UNITED STATES PATENT AND TRADEMARK OFFICE

APPLICATION NO.	FILING DATE	FIRST NAMED INVENTOR	ATTORNEY DOCKET NO.	CONFIRMATION NO.
10/562,972	12/29/2005	Yasuhiro Miyamoto	Q92215	3619
23373	7590	11/01/2007	EXAMINER	
SUGHRUE MION, PLLC			MULLINS, BURTON S	
2100 PENNSYLVANIA AVENUE, N.W.			ART UNIT	PAPER NUMBER
SUITE 800				2834
WASHINGTON, DC 20037				
MAIL DATE		DELIVERY MODE		
11/01/2007		PAPER

Office Action Summary	Application No.	Applicant(s)	
	10/562,972	MIYAMOTO ET AL.	
	Examiner	Art Unit	
	Burton S. Mullins	2834

DETAILED ACTION

FIG. 1 (b)

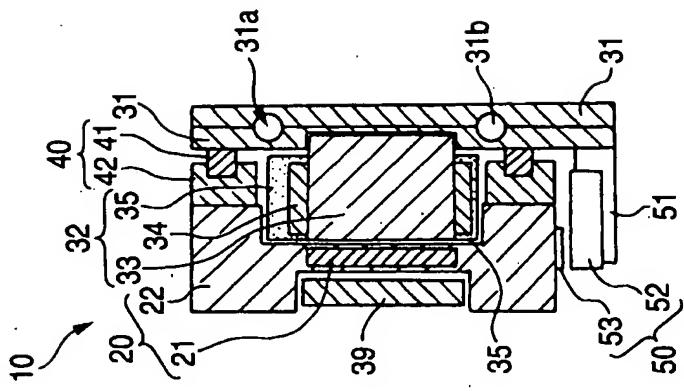
5. The disclosure is objected to because of the following informalities: References to specific claims should be deleted since the claims may be amended and re-numbered during prosecution. Also, in the description of drawings, p.9, specific reference to Figs.1a-1b and 3a-3b should be made, rather than to "Fig.1" and "Fig.3". Appropriate correction is required.
